**RE: DAILEY DRIVE LIFT STATION
MITCHELL, SOUTH DAKOTA
SPN #15405**

ADDENDUM NUMBER 1

The following modifications are to be made to the plans and specifications for the Dailey Drive Lift Station Project.

GENERATOR CONCRETE PAD — PLAN VIEW

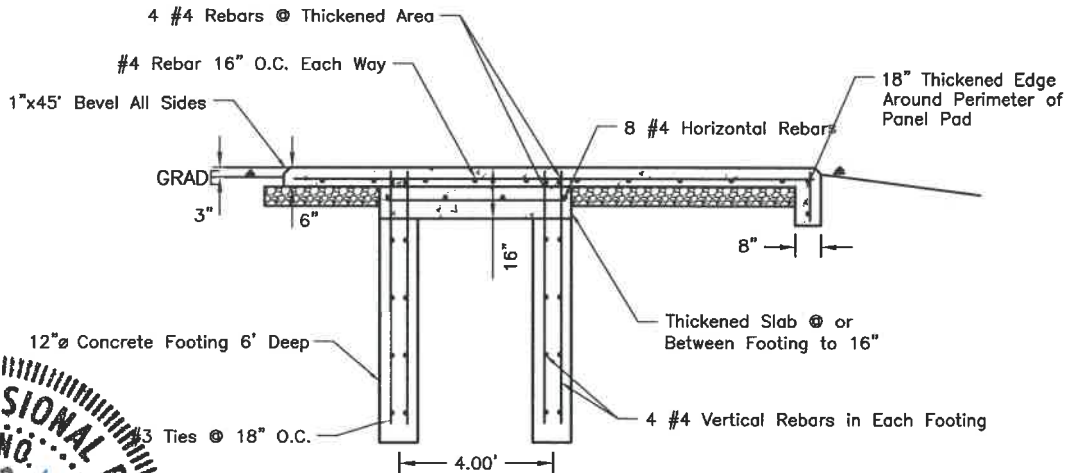
Plan Sheet 42:

Replace Plan Sheet 42 with the attached detail.

- 1.) Wiring penetrations for generator and Automatic Transfer Switch shall be provided by Blockouts or conduit, as required.
- 2.) Refer to specifications for Generator requirements
